## Board of Aldermen Request for Action

**AGENDA ITEM:** Resolution 1194, Final Plat Fairview Crossing North Subdivision

STAFF REPORT  
February 10, 2023  
Platting of Parcel Id # 05-917-00-07-008.00

FINAL PLAT OF  
**FAIRVIEW CROSSING NORTH**  
 A TRACT OF LAND IN THE SOUTHWEST QUARTER OF SECTION 35,  
 TOWNSHIP 53 NORTH, RANGE 33 WEST, CLAY COUNTY, MISSOURI

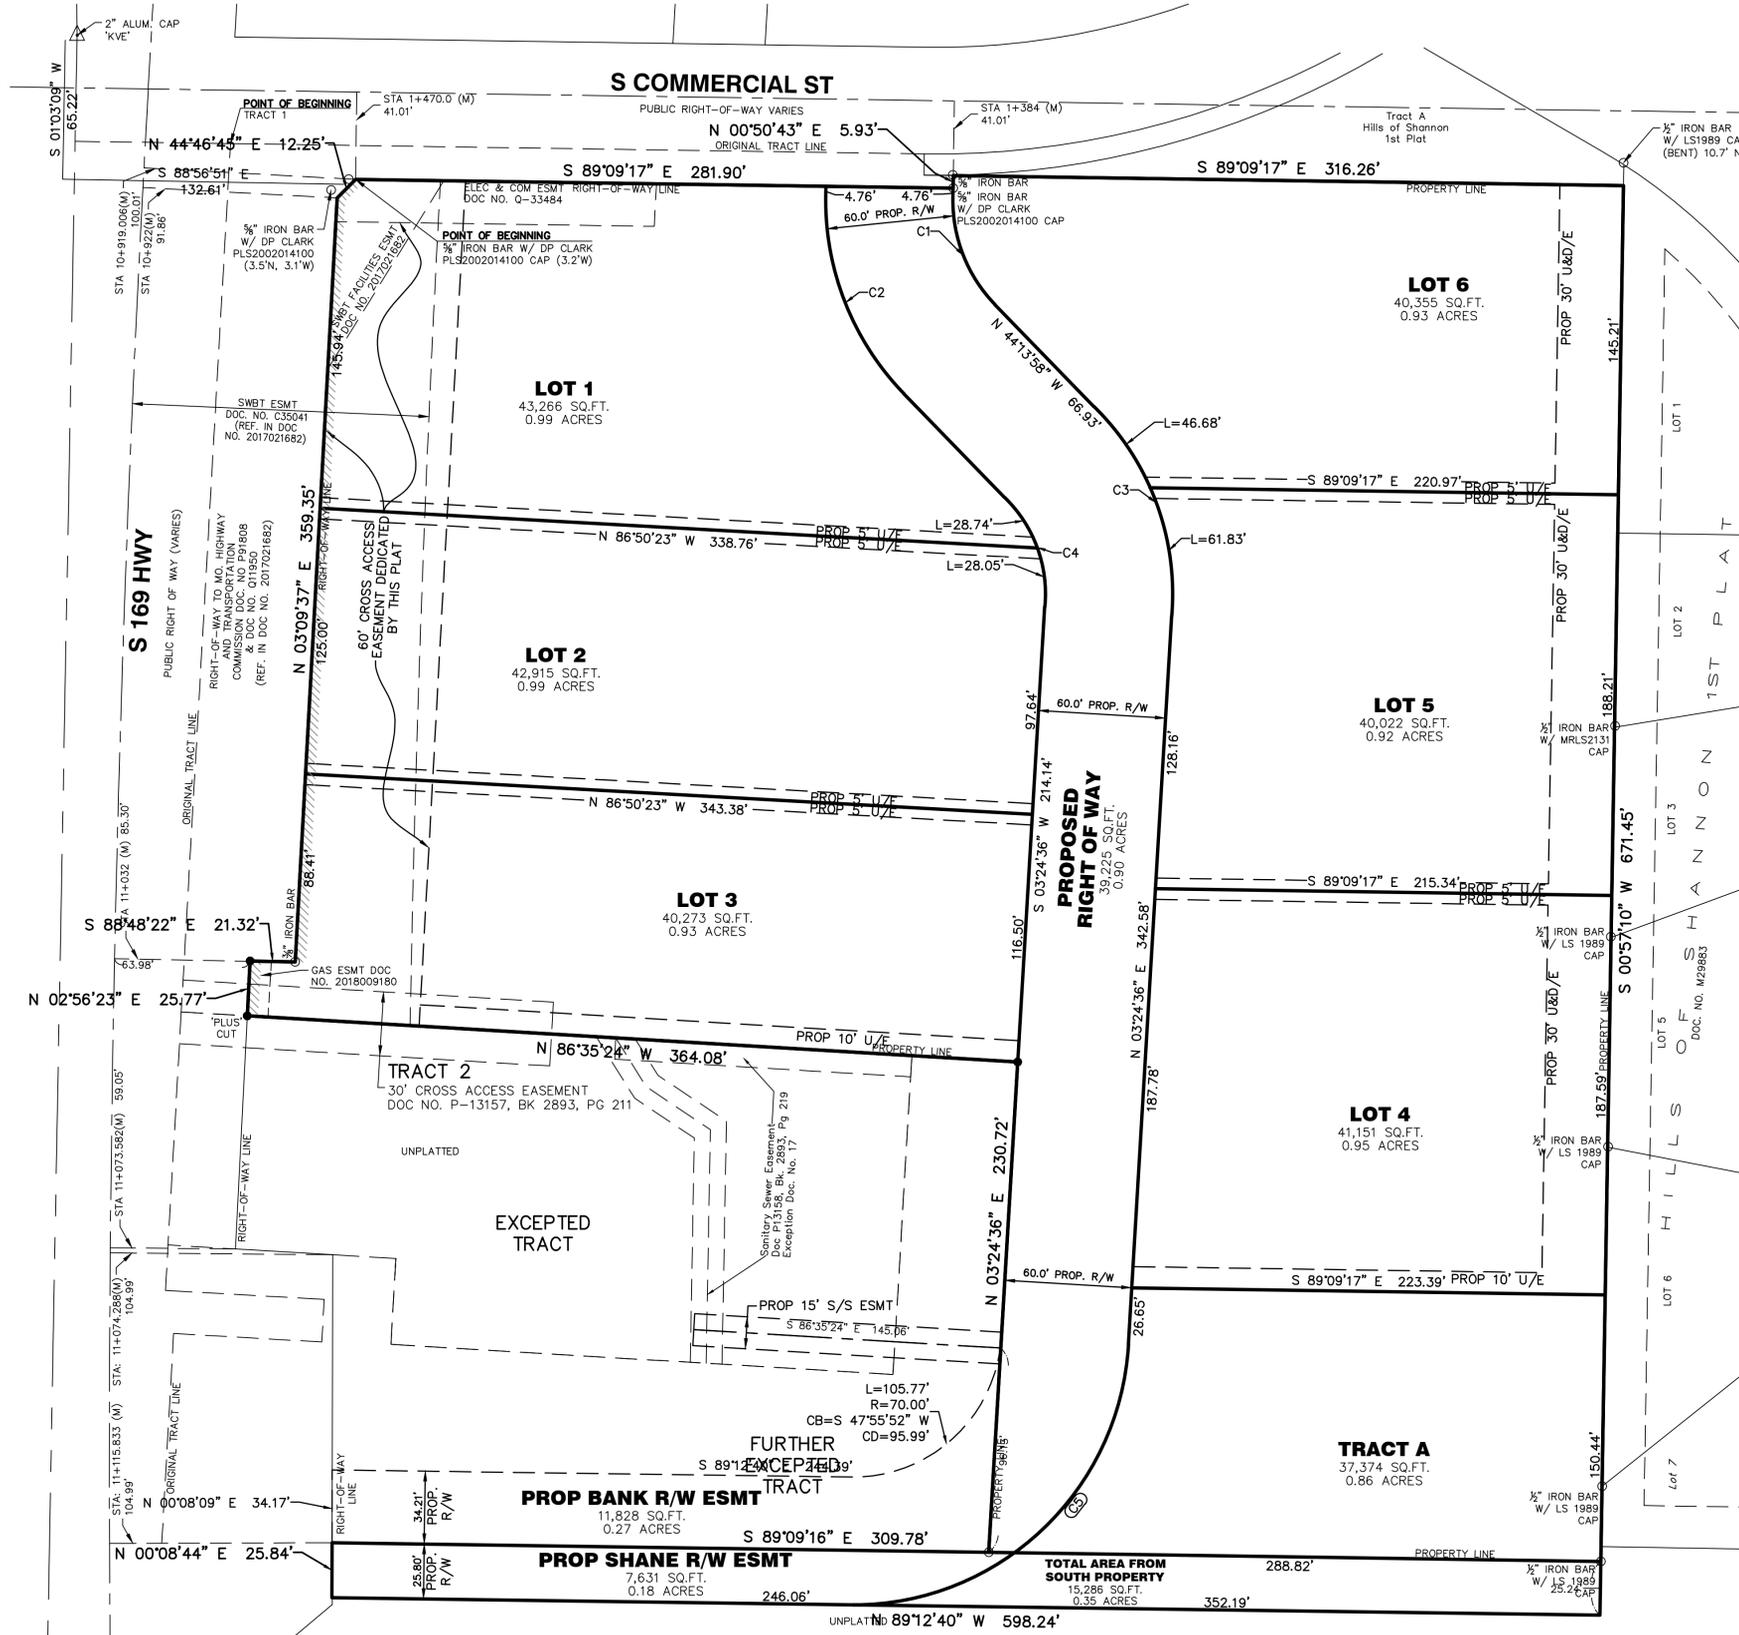
- a. The plat conforms to these regulations and the applicable provisions of the Zoning Ordinance and other land use regulations. ***Yes, the layout complies with zoning and subdivision requirements if the conceptual plan is approved.***

- c. The development shall be laid out in such a way as to result in:
  - (1) Good natural surface drainage to a storm sewer or a natural watercourse. ***Yes, the existing drainage areas are being utilized as both detention areas and natural basins.***

- (2) A minimum amount of grading on both cut or fill and preservation of good trees and other desirable natural growth. ***Yes, while there will be removal of the small invasive trees on the central portion of the land but preserves and utilizes the existing vegetation along the border with the residential area to the east to improve the required buffering.***

g. The plat shall comply with the stormwater regulations of the City and all applicable storm drainage and floodplain regulations to ensure the public health and safety of future residents of the subdivision and upstream and downstream properties and residents. The Commission shall expressly find that the amount of off-site stormwater runoff after development will be no greater than the amount of off-site stormwater runoff before development. ***The proposed design area for detention will improve the drainage onto the property to the south and to the east thereafter. The stormwater study is accepted with changes to the final construction plans, and the study must be updated to reflect the approved final construction plan to verify continued compliance.***

k. The applicant agrees to dedicate land, right-of-way and easements, as may be determined to be needed, to effectuate the purposes of these regulations and the standards and requirements incorporated herein. ***Yes, applicant has dedicated sufficient land for access roads to both 169 and Commercial, which include commercial sidewalks to improve connectivity and walkability.***

Staff recommends APPROVAL of the proposed Final Plat conditioned upon meeting the requirements of the City's Engineering Comments letter dated January 27, 2023, and approval of the Conceptual Plan considered earlier at the same meeting. Development is conditioned upon acceptance by Public Works and Engineering of ALL design plans for water, sewer, street and storm construction plans. Storm study must be updated to reflect any changes required in the final construction plans approved by the city's engineer.
